Access Compliance Report

Public Rights-of-Way

(Curb Ramps)

Intersection ID: 3889	Main Street: BICKHAM_LN	Cross Street: NEUHOFF_LN	Location: NW
ADA ID: 5019252DA530	Ramp Type: Perp	Initial Pass/Fail: Fail	Overall Compliance: No
Severity Score: 46.25			
Codes/Mitigation Info/Possible Solution		Field Measurements/Component Compliance

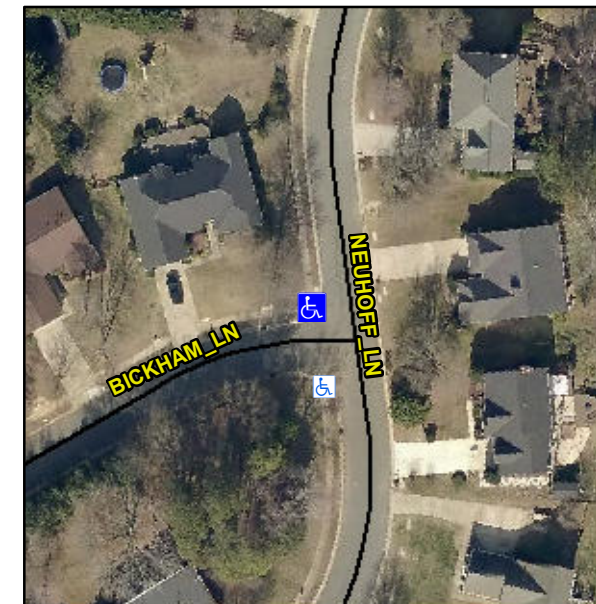
Not Found, R304.5.1, R304.2.2, R304.5.3

Compliance	Description	Data	Compliance	Description	Data
N/A	Ramp Length (in)	65.5	No	Ramp Slope (%)	8.9
No	Ramp Width (in)	40.5	No	Ramp XSlope (%)	9.1
N/A	Flare Type LT	N/A	N/A	Flare Type RT	N/A
N/A	Flare Slope LT (%)	N/A	N/A	Flare Slope RT (%)	N/A
N/A	Flare Traversable LT?	N/A	N/A	Flare Traversable RT?	N/A
N/A	Landing Length (in)	N/A	N/A	DWS Provided?	N/A
N/A	Landing Width (in)	N/A	N/A	DWS Contrast?	N/A
N/A	Landing Slope (%)	N/A	N/A	DWS Length (in)	N/A
N/A	Landing X Slope (%)	N/A	N/A	DWS Full Width?	N/A
N/A	Landing Curb? (Y/N)	N/A	N/A	DWS Offset (in)	N/A
N/A	Shared Landing?	N/A			
N/A	Gutter Ponding?	N/A	N/A	Gutter Slope (%)	N/A
N/A	Gutter Lip Ht (in)	N/A	N/A	Gutter X Slope (%)	N/A
N/A	Painted X Walk1?	No	N/A	Painted X Walk2?	N/A
	X Walk 1 Direction	To S		X Walk 2 Direction	N/A
N/A	X Walk 1 Width (in)	N/A	N/A	X Walk 2 Width (in)	N/A
	X Walk 1 Slope (%)	3.6		X Walk 2 Slope (%)	N/A
	X Walk 1 X Slope (%)	8.3		X Walk 2 X Slope (%)	N/A

Remove & Replace Entire Ramp.
